SUBJECT: Recall Campaign 094 - Front Passenger Seat Belt Tension Sensor Wiring Harness - TSB# 10-01-008

Hyundai Motor America is conducting a Customer Notification to repair the Front Passenger Seat Belt Tension Sensor Wiring Harness on certain 2006 - 2009 Model Year Azeras produced from the start of production to October 10, 2008.

Model: Azera (TG)

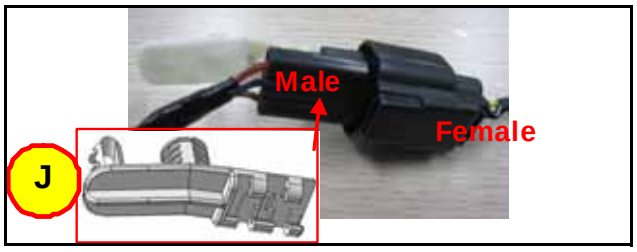
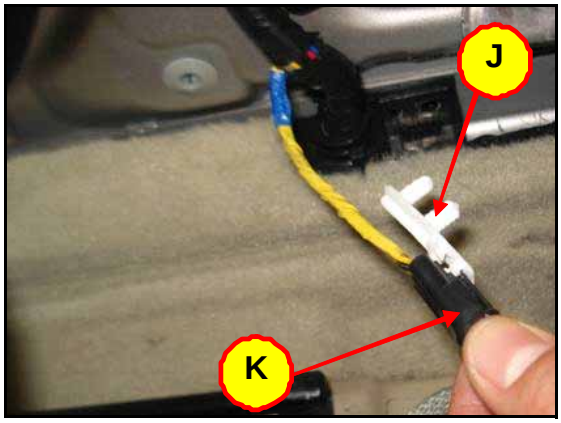
11. Remove the front passenger seat's BTS wire harness fixing clip (I).

12. Fit the newly supplied clip (J) to the male connector (K) of the BTS wire harness and reconnect the connector.

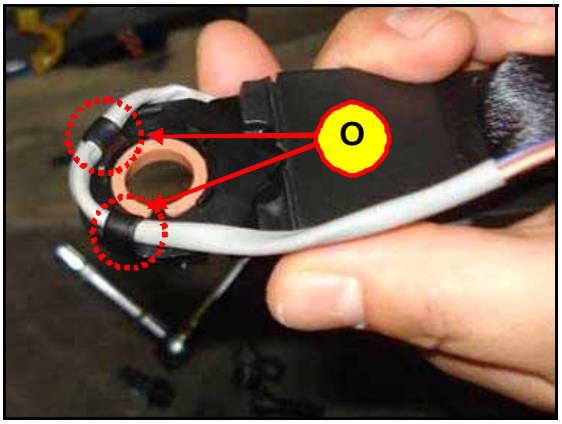
5. Pull the BTS wire harness off the guides (O).

- Use caution so that the wire protection is not damaged.

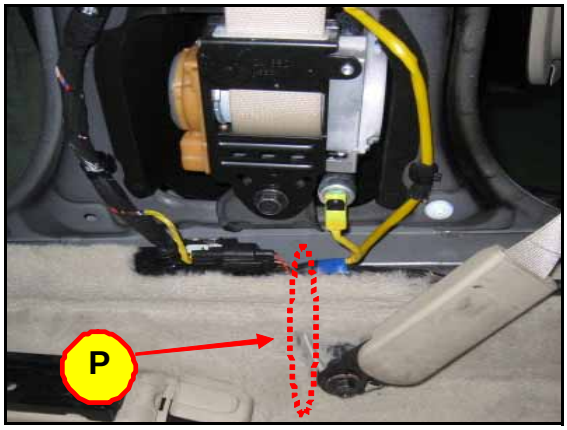
- Insert the BTS wire harness through the slot hole on the left of the lower anchor bolt hole (P).

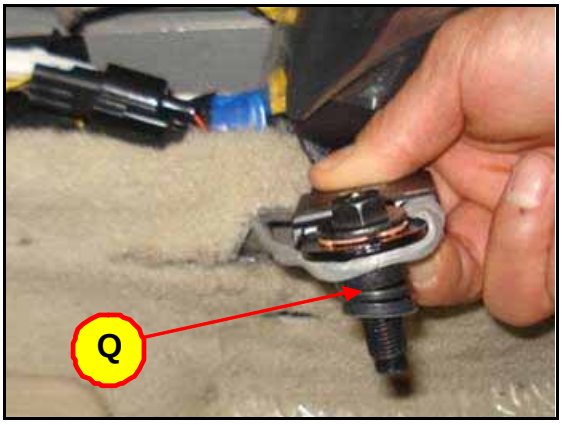
- Place the BTS wire harness below the spacer (Q) as shown in the picture and then fasten the lower anchor bolt.

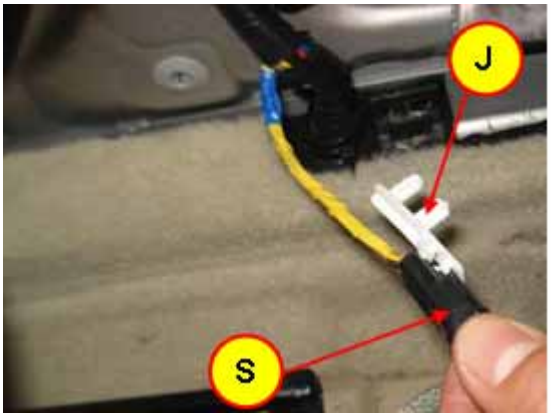
9. Fit the newly supplied clip (J) to the male connector (S) of the BTS wire harness and reconnect the connector.
